## **Appendix 35**

Road Safety Audit Stage 1 2018 and Designer's Response

**Land at Peel Hall, Warrington  
Access Strategy (Provision of or Modifications to 12 Junctions)  
Road Safety Audit Stage 1**

**Report No 16/2018**

## Reference Plan

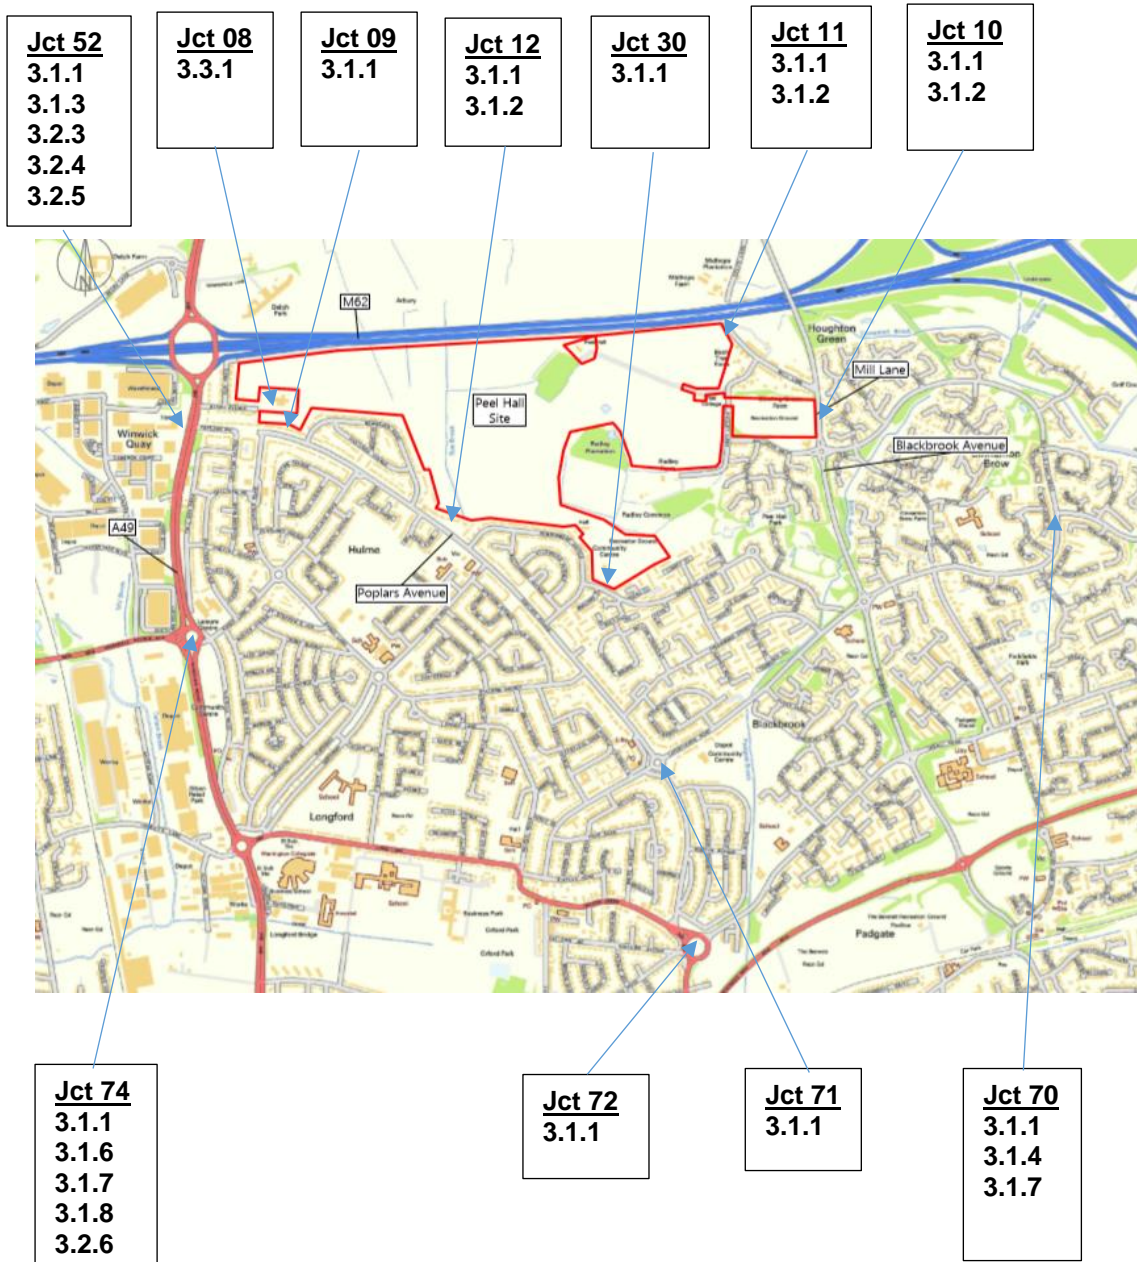
**Location:** Poplars Avenue/Cotswold Road Junction (Junction 09), Blackbrook Avenue Roundabout (Junction No 10), Mill Lane (Junction 11), Grasmere Avenue (Junction 30), A49/Poplars Avenue Junction (Junction 52), Crab Lane/Enfield Park Road Junction (Junction 70), Capesthorpe Road/Poplars Avenue Roundabout (Junction 71), A50/Hilden Road/Poplars Avenue Roundabout (Junction 72) and A49/Sandy Lane West Junction (Junction 74). (*Drawings No 1107 09/M, 1107 10/N, 1107 11/L, 1107 30/H, 1107 53/E, 1107 70, 1107 71, 1107 72 and 1107 74*)

**Summary:** Loss of control collisions could occur where the carriageway has been widened or realigned.

At each of the above junctions the proposals involve the construction of areas of new carriageway abutting existing surfaces. If the joints are not smooth and clean or the new surface has a significantly different PSV from the existing, drivers could lose control of their vehicles in wet conditions due to differential grip.

**Location:** Blackbrook Avenue Roundabout (Junction 10). (*Drawing No 1107 TR10A*)

**Summary:** Vehicles entering the roundabout from lane two from the southern and western approaches could be squeezed out by others entering from lane one resulting in vehicle/vehicle collisions or collisions with the central island.

When travelling south to north and west to south traffic entering the roundabout from lane one of both western arms will tend to move to their right towards the central circular island of the roundabout. In doing so they will squeeze out vehicles undertaking the same turning movements from lane two of both approaches resulting in vehicle/vehicle collisions on the circulatory carriageway or the vehicle from lane two collided with the central circular island itself.

**Location:** A49/Poplars Avenue Junction (Junction 52). (*Drawing No 1107 TR52*)

**Summary:** The higher speed A49 approaches could result in shunt type collisions on the approaches to the traffic signals

**Location:** Crab Lane/Enfield Park Road Junction (Junction 70). (*Drawing No 1107 70*)

**Summary:** The higher speed approaches could result in shunt type collisions on the approaches to the traffic signals

**Location:** Crab Lane/Enfield Park Road Junction (Junction 70). (*Drawing No 1107 70*)

**Summary:** Foliage from adjacent trees and the hedge could obscure the traffic signals on the western side of the junction. Drivers may consequently not see the signal and be involved in overshoot or turning vehicle collisions.

**Location:** Winwick Road arm of the A49/Sandy Lane West Junction (Junction No 74). *(Drawing No 1107 74)*

**Summary:** Visibility to the right for vehicles emerging from Winwick Road will be impaired. Turning vehicle collisions could consequently occur.

**Location:** Sandy Lane West entry to the A49/Sandy Lane West Junction (Junction No 74). *(Drawing No 1107 74)*

**Summary:** During peak traffic conditions drivers may seek to turn left onto the A49 from lane two across the path of vehicles crossing the junction from lane one. Turning vehicle collisions may consequently occur.

**Location:** Circulatory Carriageway of the A49/Sandy Lane West Junction (Junction No 7452). *(Drawing No 1107 74)*

**Summary:** There is a pinch point on lane one of the circulatory carriageway adjacent to the central reserve of the A49 Winwick Road southern arm. Traffic using lane one may collide with the central reserve or collide with a vehicle in lane two.

**Location:** Poplars Avenue at the proposed Pedestrian Crossing near its western junction with Windermere Avenue (Junction No 12). (*Drawing No 1107 12/Q*)

**Summary:** Buses stopped in the proposed bus bays will cut off visibility of pedestrians approaching the crossing. Vehicle/pedestrian collisions could consequently occur.

**Location:** Roundabout on the Residential Land and Local Centre Link from Poplars Avenue (Junction No 12). (*Drawing No 1107 12/Q*)

**Summary:** The splitter island on the western arm is too narrow to accommodate cyclists.

**Location:** A49/Poplars Avenue Junction (Junction No 52). (*Drawing No 1107 TR52*)

**Summary:** The more southerly triangular shaped splitter island on Poplars Avenue is too narrow to accommodate cyclists.

**Location:** A49/Poplars Avenue Junction (Junction No 52). (*Drawing No 1107 TR52*)

**Summary:** Cyclists appear to be crossing the A49 carriageway at the junction. The lack of a crossing facility may lead to vehicle/cyclist collisions.

**Location:** A49/Poplars Avenue Junction (Junction No 52). (*Drawing No 1107 TR52*)

**Summary:** The proximity of the vehicle Stop Lines on the Poplar Avenue arm are too close to the pedestrian crossing places. This could lead to vehicles striking pedestrian.

**Location:** A49/Sandy Lane West Junction (Junction No 74). (*Drawing No 1107 74*)

**Summary:** The proximity of the vehicle Stop Lines on the Sandy Lane West are too close to the pedestrian crossing places. This could lead to vehicles striking pedestrian.

**Location:** Birch Avenue (Junction 08). (*Drawing No 1107 08/P*)

**Summary:** If provided, drivers and riders may not recognise the ramp near No 27 Birch Avenue and lose control of their vehicle.

**Location:** Mill Lane (Junction 11). (*Drawing No 1107 11/L*)

**Summary:** Drivers and riders may not recognise the raised table and lose control of their vehicle.

<b>Para. No.</b>	<b>Problem</b>	<b>Recommendation</b>	<b>Designers Response</b>
3.1.1	At all junctions the proposals involve the construction of areas of new carriageway abutting existing surfaces. If the joints are not smooth and clean or the new surface has a significantly different PSV from the existing, drivers could lose control of their vehicles in wet conditions due to differential grip.	Ensure that the interfaces between the existing and new surfaces are structurally secure, clean and sound. In addition, provide a wearing course on the new sections of carriageway with a similar wet skid resistance to the existing surface, assuming that the existing surface is above investigatory levels.	Accepted.

Para. No.	Problem	Recommendation	Designers Response
3.1.2	<p>Blackbrook Avenue Roundabout (Junction 10). (Drawing No 1107 TR10A).</p> <p>When travelling south to north and west to south traffic entering the roundabout from lane one of both western arms will tend to move to their right towards the central circular island of the roundabout. In doing so they will squeeze out vehicles undertaking the same turning movements from lane two of both approaches resulting in vehicle/vehicle collisions on the circulatory carriageway or the vehicle from lane two collided with the central circular island itself.</p>	<p>1. Realign both entries so that the approach splitter islands direct lane two traffic off the central circular island, with an associated adjustment to the alignment of lane one; and</p> <p>2. Provide lane destination arrows on the roundabout approaches to encourage 'correct lane' use.</p>	1 & 2 – Noted, this will be provided for the Stage 2 RSA / at detailed design stage.

3.1.3	<p>A49/Poplars Avenue Junction (Junction 52). (Drawing No 1107 TR52).</p> <p>Traffic on both A49 approaches tend to travel at higher speeds and as a result may have to brake sharply when the signals change and/or other vehicles slow or stop. Sharp braking could lead to rear end shunt type collisions.</p>	Provide high friction surfacing on both A49 approaches to the signal controlled junction.	Noted.

3.1.4	<p>Crab Lane/Enfield Park Road Junction (Junction 70). (Drawing No 1107 70)</p> <p>Traffic on all three approaches to this junction tends to travel at higher speeds and as a result may have to brake sharply when the signals change and/or other vehicles slow or stop. Sharp braking could lead to rear end shunt type collisions.</p>	Provide high friction surfacing on both all three approaches to the signal controlled junction.	Noted.

Para. No.	Problem	Recommendation	Designers Response
3.1.5	<p>Crab Lane/Enfield Park Road Junction (Junction 70). (Drawing No 1107 70)</p> <p>During the growing season foliage from the trees and hedge on the western side of Enfield Park Road may obscure a driver's view of primary signal head facing northbound traffic. If a driver does not see a signal head, they may continue without stopping resulting in overshoot or turning vehicle collisions.</p>	Cut back, or if feasible remove, the foliage to provide a clear view of the signals.	Noted.

3.1.6	<p>Winwick Road arm of the A49/Sandy Lane West Junction (Junction No 74). (Drawing No 1107 74)</p> <p>Setting back the give way line as proposed on Winwick Road will result in significantly reduced visibility to the right for emerging vehicles. This situation will be worsened as traffic approaching the signalized roundabout from Sandy Lane West will be breaking out into the three lanes on the immediate approach to signals. Turning vehicle collisions are likely to occur at this point due to the restricted visibility.</p>	Do not set back the give way line as proposed.	<p>These proposed junction mitigation works have been revised to improve visibility from the minor Winwick Road arm, and also to ensure that all works are contained to highway owned land.</p> <p>The visibility splay to the right along Sandy Lane West has been shown as achievable in excess of 25m in accordance with the 20mph signed speed limit along this road.</p>

<b>Para. No.</b>	<b>Problem</b>	<b>Recommendation</b>	<b>Designers Response</b>
3.1.7	<p>Sandy Lane West entry to the A49/Sandy Lane West Junction (Junction No 74). (Drawing No 1107 74)</p> <p>During peak traffic conditions when vehicles could be queuing and drivers seeking to take any advantage, those drivers wishing to enter the southern arm of A49 Winwick Road from Sandy Lane West may seek to turn left from lane two of the approach. In doing so they may cross the path of another vehicle travelling straight across the junction from lane one, resulting in turning vehicle collisions.</p>	Modify the layout to discourage this potential manoeuvre.	The proposed road markings will direct traffic to the appropriate destinations. It should be noted that the demand for left turning manoeuvres from Sandy Lane West to A49 southbound is low compared to other movements from this arm.

3.1.8	<p>Circulatory Carriageway of the A49/Sandy Lane West Junction (Junction No 7452). (Drawing No 1107 74)</p> <p>In lane one of the circulatory carriageway a pinch point exists on the eastern side of central reserve of the A49 Winwick Road southern arm. Drivers, especially those in larger vehicles, may consequently either collide with the central reserve or move across into lane two potentially colliding with another vehicle in that lane.</p>	Modify the layout to provide a consistent width to lane one.	This drawing has been modified as is included within the TA.

<b>Para. No.</b>	<b>Problem</b>	<b>Recommendation</b>	<b>Designers Response</b>
3.2.1	<p>Poplars Avenue at the proposed Pedestrian Crossing near its western junction with Windermere Avenue (Junction No 12). (Drawing No 1107 12/Q)</p> <p>The proposed bus bays are positioned on the approach to the pedestrian crossing within the crossing control area. A bus stopped in either bay could curtail the view of an approaching driver and as a result they may not see a pedestrian approaching the crossing or seeking to cross. Vehicle/pedestrian collisions could consequently occur.</p>	Reposition the bus bays to a point on the exit sides of the pedestrian crossing.	Offside primary signal heads will be provided to overcome this issue.

3.2.2	<p>Roundabout on the Residential Land and Local Centre Link from Poplars Avenue (Junction No 12). (Drawing No 1107 12/Q)</p> <p>Cyclists using the shared footway/cycleway on the western side of the link road between Poplars Avenue and the roundabout may seek to continue their journey utilizing the splitter island on the western side of the roundabout. The proposed splitter island is, however, of insufficient width to accommodate a bicycle clear of the carriageway. Passing vehicles may consequently collide with the bicycle overhanging the island.</p>	Widen the splitter island.	This is not a crossing point for cyclists, notwithstanding this the splitter island measures 2m in width, which is suitable for cyclists.

<b>Para. No.</b>	<b>Problem</b>	<b>Recommendation</b>	<b>Designers Response</b>
3.2.3	<p>A49/Poplars Avenue Junction (Junction No 52). (Drawing No 1107 TR52)</p> <p>Cyclists using the shared footway/cycleway on the eastern side of the A49 may seek to continue their journey utilizing the splitter islands on Poplars Avenue. The proposed more southerly splitter island is, however, of insufficient width to accommodate a bicycle clear of the carriageway. Passing vehicles may consequently collide with a bicycle overhanging the island. In addition, the island may be too small to accommodate a double headed signal installation and consequently vehicles may collide with signal heads as they pass.</p>	Widen the splitter island.	All splitter islands at the proposed junction are at least 2m wide at the centre, which is considered suitable for cyclists.

3.2.4	<p>A49/Poplars Avenue Junction (Junction No 52). (Drawing No 1107 TR52)</p> <p>There is evidence of cycle movements across the eastern verge of the A49 on the northern side of the junction suggesting that cyclists are crossing the A49 carriageway at this point. The attractors on the western side of the A49 may also encourage similar pedestrian movements. No proposals exist, however, to assist these movements if they do occur and hence vehicle/cyclist and/or vehicle/pedestrian collisions may occur.</p>	Review the necessity for a cyclist and/or pedestrian crossing facility on the A49 and provide a crossing place if appropriate.	It is proposed that, as part of these works, tactile paving and widening could be provided to the existing uncontrolled crossing circa 60m to the south of this junction, in the vicinity of the southbound bus stop,

<b>Para. No.</b>	<b>Problem</b>	<b>Recommendation</b>	<b>Designers Response</b>
3.2.5	<p>A49/Poplars Avenue Junction (Junction No 52). (Drawing No 1107 TR52)</p> <p>The distance between the pedestrian crossing studs on the Poplar Avenue arm and the vehicle Stop Lines are not specified. Collisions can occur at signal controlled crossings because drivers of high fronted vehicles can pull away unaware of the presence of pedestrians who cross close to their vehicle.</p>	Provide a 3m gap between the Stop Lines and the pedestrian crossing place	Accepted. This has been provided on the revised drawing within the TA.

3.2.6	<p>A49/Sandy Lane West Junction (Junction No 74). (Drawing No 1107 74)</p> <p>The distance between the pedestrian crossing studs on the Sandy Lane West arm and the vehicle Stop Lines are not specified. Collisions can occur at signal controlled crossings because drivers of high fronted vehicles can pull away unaware of the presence of pedestrians who cross close to their vehicle.</p>	Provide a 3m gap between the Stop Lines and the pedestrian crossing place.	The stop line will be provided as per the existing situation.

<b>Para. No.</b>	<b>Problem</b>	<b>Recommendation</b>	<b>Designers Response</b>
3.3.1	<p>Birch Avenue (Junction 08). (Drawing No 1107 08/P)</p> <p>As there are no other ramps or humps on Birch Avenue, drivers or riders may not recognise the presence of the proposed ramp at the change of surfacing near No 27 Birch Avenue, especially in the dark or in poor weather conditions. Drivers or riders could consequently lose control of the vehicle and collide with other road users or roadside features.</p>	<p>If a ramp is provided, provide hump warning signs in advance of the feature and 'sharks teeth' markings on the ramp.</p>	<p>Accepted. Will be considered further at detailed design stage.</p>

3.3.2	<p>Mill Lane (Junction 11). (Drawing No 1107 11/L)</p> <p>As there are no other raised tables or humps Mill Lane, drivers or riders may not recognise the presence of the proposed table at the junction, especially in the dark or in poor weather conditions. Drivers or riders could consequently lose control of the vehicle on the tables ramps and collide with other road users or roadside features.</p>	<p>Provide hump warning signs on the approaches to the raised table.</p>	<p>Accepted. Will be considered further at detailed design stage.</p>
